Salon Loge Construction

Building a 200' Nautilus, Plans by David McCamant

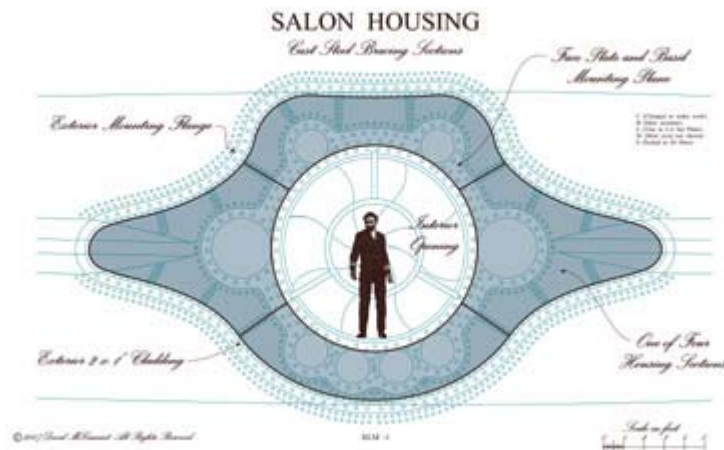
I can't really see much of the actual construction of the the Viewport. It looks great. The only small change I would make is to round the ends of the glass bracing -where it meets the frame and where it meets the center ring- to depict a rounded cross section.

Hi Sourdoh, I'm not sure about the revisions you would like to see but if you could clarify them, I would be happy to make any changes. The drawing is more of an overview to show the 4 large cast pieces. I think I have a pretty good solution now based on everyones input so...here it is!

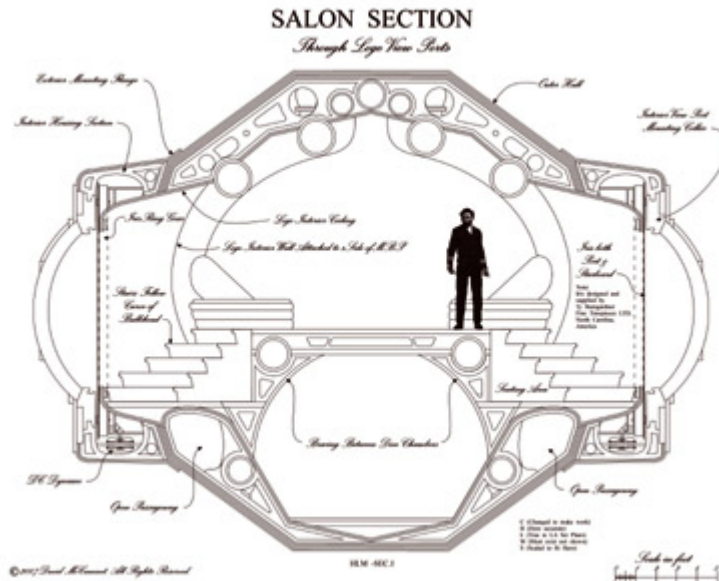
I am probably missing something, but isn't that a lot of steps to the floor of the loge?

Dave, what I'm seeing is five steps, the first being level with the salon floor. Would it work out to eliminate the top step and move the whole flight back so the second step sits against the bay cutout in the salon floor? That would open up additional leg room. Or is that top step actually part of the floor, undercut for the customary toe room?

Hi Aeolian, You are right Sir there are 2 more 9" steps than the set plans and about 6" less leg room too. These plans are to match my drawings for the 200 LOA thread (so I don't have to do them twice). To fit the dive chambers and changing rooms below, the salon floor needs to be about 18 inches higher. Actually, now that I think about it, the whole room moved up 18". The structure of the housing though wouldn't change much even with being true to the live action sets.

Hi Mates, What? I'm a little confused about eliminating the top step. It's...the...top...step or opening in the floor...ah...you sort of need a top step. The figure of Nemo is standing on the deck of the salon which ends as the opening (with the customary undercut). One thing that's a bit hard to see is that where the flat face of the stairs are is the vertical drop to the loge deck; or the end of the loge arc. The top stair is not a landing. As you all know, the loge is
